STAFF REPORT: 05/08/2024 MEETING
APPLICATION NUMBER: HDC20204-00166
ADDRESS: 150 STATE
HISTORIC DISTRICT: CAPITOL PARK
APPLICANT: JAMES FIDLER/DOWNTOWN DETROIT PARTNERSHIP
OWNER: CITY OF DETROIT, GENERAL SERVICES DEPARTMENT
DATE OF PROVISIONALLY COMPLETE APPLICATION: 4/20/2024
DATE OF STAFF VISIT: 4/22/2024

SCOPE OF WORK: REHABILITATE PARK

Mason monument, current appearance. Staff photo taken on 4/22/2024. The red outline indicates the original/1908 portion of the monument. The area outlined in yellow is the pedestal/vault that was installed in 2010 and currently houses Mason's remains.

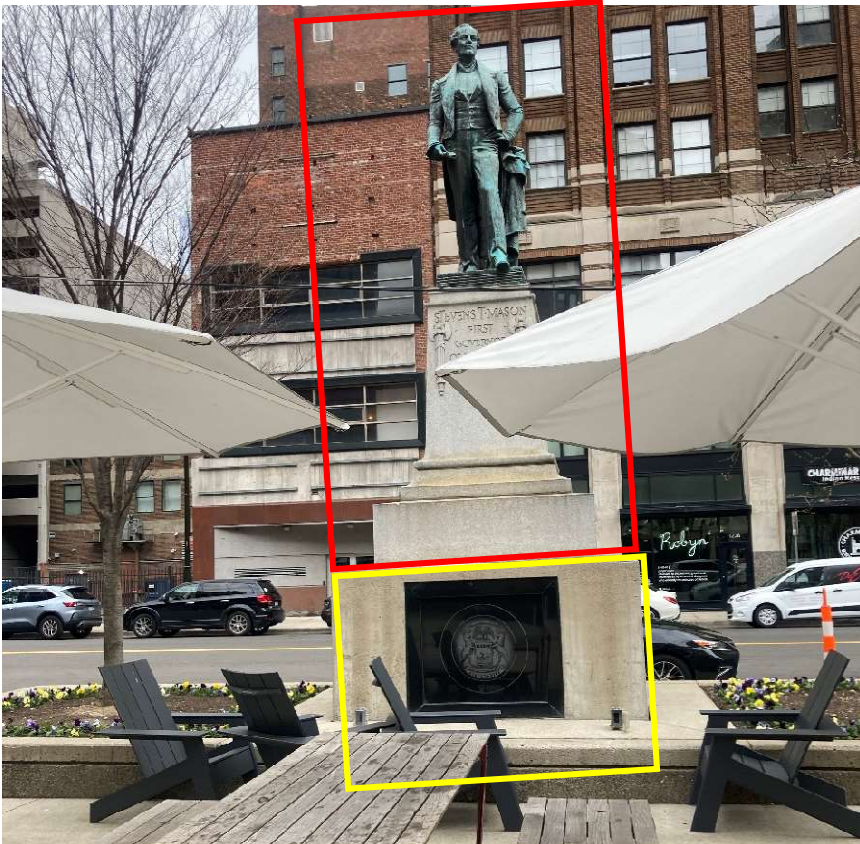
- The Stevens T. Mason monument includes a bronze statue and limestone pedestal, both dating from 1908, and a masonry base/burial vault, which dates from 2010. The remains of Stevens T. Mason were interred within the masonry vase/burial vault in 2010 (see below photo on page 15). As stated above, the historic statue and masonry base has been moved at least two times since the date of the monument’s original construction. Also, the original balustrade/exedra and light posts had been removed from the monument by 1955. Despite the relocations and removal the original balustrade, the district’s historic designation report has identified the monument as a contributing element to the district.

- The HDAB designation report has determined that the historic monument as discrete object/a whole is a Contributing feature of the district. Staff does not recommend the dismantling of this historic object/the statue from its original base and/or the installation of a new obelisk in its place as it will result in a false sense of historic development within the park and therefore does not meet the Secretary of Interior’s Standards for Rehabilitation, Standard # 3 which states the following:

- Although the 2010 pedestal is not historic-age, it does contain the Stevens T. Mason’s remains. When originally erected, the monument was meant to mark the location of Mason’s grave. It is believed that the work undertaken within the park in 1955, to include the relocation of the monument, resulted in the separation of the grave from the monument. The erection of the current base/vault in 2010 and the reinternment of Mason’s remains within appears to be an effort to permanently reestablish the historic relationship between the grave and the monument. The proposed statue relocation would sever that historic relationship.

- As noted, it is staff’s opinion that the Mason monument’s bronze statue and original 1908 granite pedestal should remain conjoined as a single object and Mason’s remains should be retained as an integral element of the monument/grave site. However, staff would not object to the relocation of the monument (to include the statue, the 1908 limestone base, and Manson’s remains) within the park as it has been moved a number of times throughout its history. Staff also would support

- The historic Stevens T. Mason monument, to include its original bronze statue and limestone base, is a contributing element to the district as a discrete/single object and was originally erected to mark Mason's grave. The proposed dismantling of this historic object/the statue from its original base, the resulting disconnection from Mason's remains, and the installation of a new obelisk on the base will result in a false sense of historic development within the park and will contribute to a diminution of features that characterize the monument. Staff therefore recommends that the Commission deny this work.

Recommendation # 1 - Section 21-2-73, DENIAL - Relocate Stevens T, Mason Statue and install an obelisk on the monument’s base

The historic Stevens T. Mason monument, to include its original bronze statue and limestone base, is a contributing element to the district as a discrete/single object and was originally erected to mark Mason’s grave. The proposed dismantling of this historic object/the statue from its original base, the resulting disconnection from Mason’s remains, and the installation of a new obelisk on the base remains will result in a false sense of historic development within the park and will contribute to a diminution of features that characterize the monument. Staff therefore recommends that the Commission issue a Denial for this work item because it does not meet the Secretary of the Interior’s Standards for Rehabilitation, in particular, Standards# 2 and 3:
